SOLICITATION AMENDMENT

Title - Sujet Concrete Wharf Repairs	
Solicitation No. - N° de l'invitation F1700-150940/A	Amendment No. - N° modif. 003
Client Reference No. - N° de référence du client	Date 2016-02-12
GETS Reference No. - N° de référence de SEAG PW-\$PWY-019-7728	
File No. - N° de dossier PWY-5-38353 (019)	CCC No./N° CCC - FMS No./N° VME
Solicitation Closes - L'invitation prend fin at - à 02:00 PM on - le 2016-02-18	
F.O.B. - F.A.B. Plant-Usine: <input type="checkbox"/> Destination: <input checked="" type="checkbox"/> Other-Autre: <input type="checkbox"/>	
Address Enquiries to: - Adresser toutes questions à: Ngan, Ken (PWY)	Buyer Id - Id de l'acheteur pwy019
Telephone No. - N° de téléphone (604) 658-2755 ()	FAX No. - N° de FAX (604) 775-6633
Destination - of Goods, Services, and Construction: Destination - des biens, services et construction: DFO - Institute of Ocean Sciences Wharf - Patricia Bay, BC

This Solicitation Amendment 003 is raised to incorporate Addendum #2, and to incorporate a revised Unit Price Table.

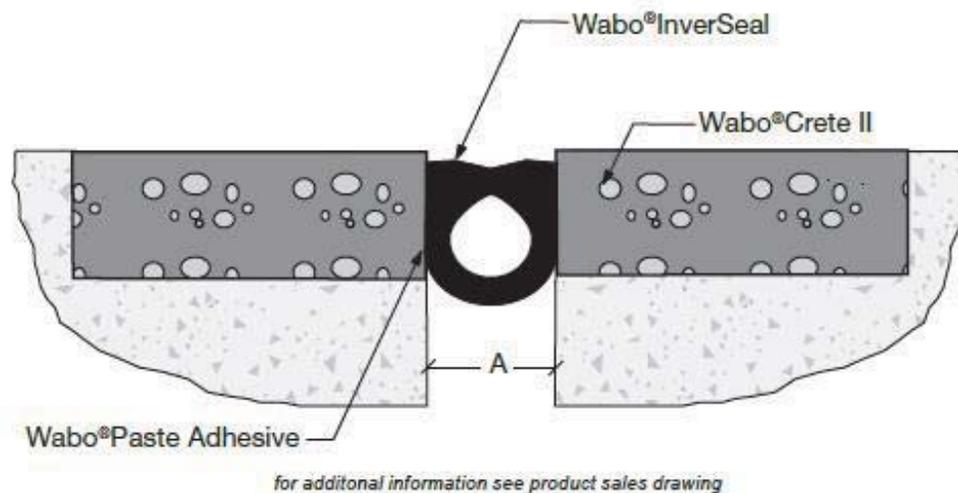
Add Part 1.6.2.4.5:

Expansion joints shall be refurbished to match existing refurbished expansion joints. It shall include a rubber expansion joint seal set into a flexible polymer mortar. Allow for sawcutting and preparing the edge of the concrete deck as shown in the sketch below. Quantity per Unit rate table, Pay Item #6 (attached). Bid value to reflect use of Wabocrete Flexfoam Model No IV 250.
